Project	IEEE 802.16 Broadband Wireless Access Working Group < http://ieee802.org/16 >	
Title	Correction of inconsistencies for 802.16-2004 OFDMA symbol clock frequency tolerance	
Date Submitted	2005-01-13	
Source(s)	Juergen Otterbach Joerg Schaepperle Roland Muenzner Torsten Fahldieck Alcatel SEL AG	Voice: +49-711-821-32255 Fax: +49-711-821-32453 juergen.otterbach@alcatel.de
Re:	Response to the call for comments 802.16maint-04/10 Corrigendum to IEEE 802.16-2004	
Abstract	Correction of inconsistencies for 802.16-2004 OFDMA	
Purpose	Resolving ambiguity in OFDMA PHY layer §8.4	
Notice	This document has been prepared to assist IEEE 802.16. It is offered as a basis for discussion and is not binding on the contributing individual(s) or organization(s). The material in this document is subject to change in form and content after further study. The contributor(s) reserve(s) the right to add, amend or withdraw material contained herein.

Correction of inconsistencies for 802.16-2004 OFDMA symbol clock frequency tolerance

*Juergen Otterbach / Joerg Schaepperle / Roland Muenzner / Torsten Fahldieck
Alcatel SEL AG*

Figure 2: Signal-to-interference ratio (SIR) as a function of the absolute tolerance of the sampling clock F_s in percent of the subcarrier spacing Δf

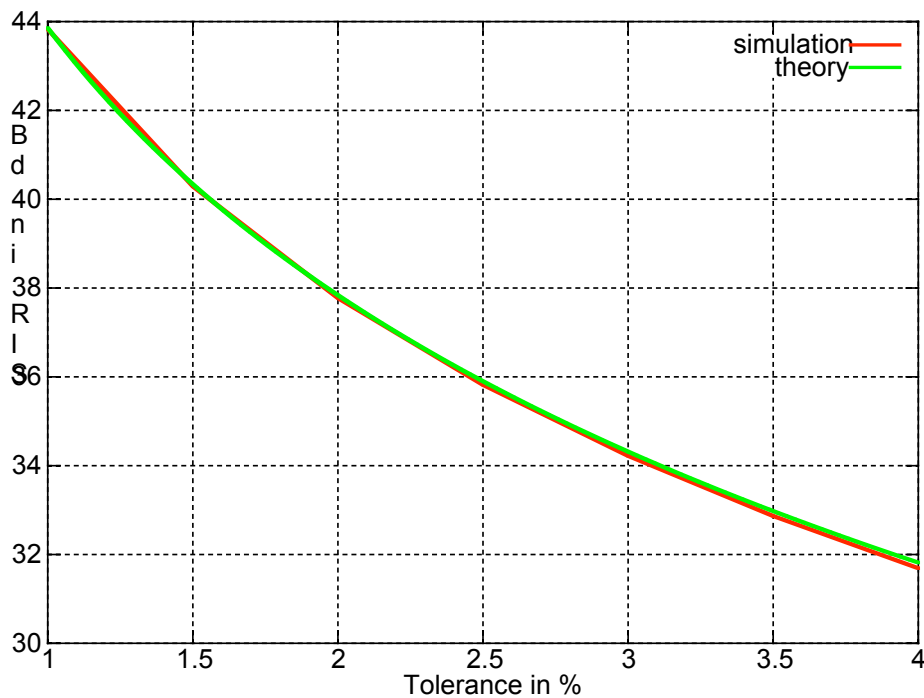
As an indication Figure 2 shows the resulting SIR values in function of the tolerance for the sampling clock frequency for a range of values, that still would leave some margin to the SNR requirement of 24.4 dB for 64 QAM.

A symbol clock frequency tolerance of 2 % of the subcarrier spacing on the other hand, as currently required in 802.16-REVd/D5, results due to the above relation between the symbol clock and the sampling clock frequency in a much higher tolerance for the sampling clock frequency. Therefore this requirement on the symbol clock frequency is not sufficient.

Even though a tolerance of the symbol clock frequency accuracy derived from the range of values for the sampling clock frequency shown in Figure 2 could be sufficient, there is a more direct means to guarantee a still higher accuracy exploiting the requirement that the symbol clock frequency and the center frequency are derived from a single reference at the BS and thus have a fixed and predefined ratio within the system.

At the SS, the transmitted center frequency ~~and the symbol clock frequency~~ shall be synchronized to the BS with a tolerance of maximum 2% of the subcarrier spacing. Additionally the symbol clock frequency at the SS shall be locked to the center frequency at the SS which guarantees a relative tolerance for the symbol clock frequency at the SS of maximum $0.02 * (\text{subcarrier spacing}) / (\text{center frequency})$.
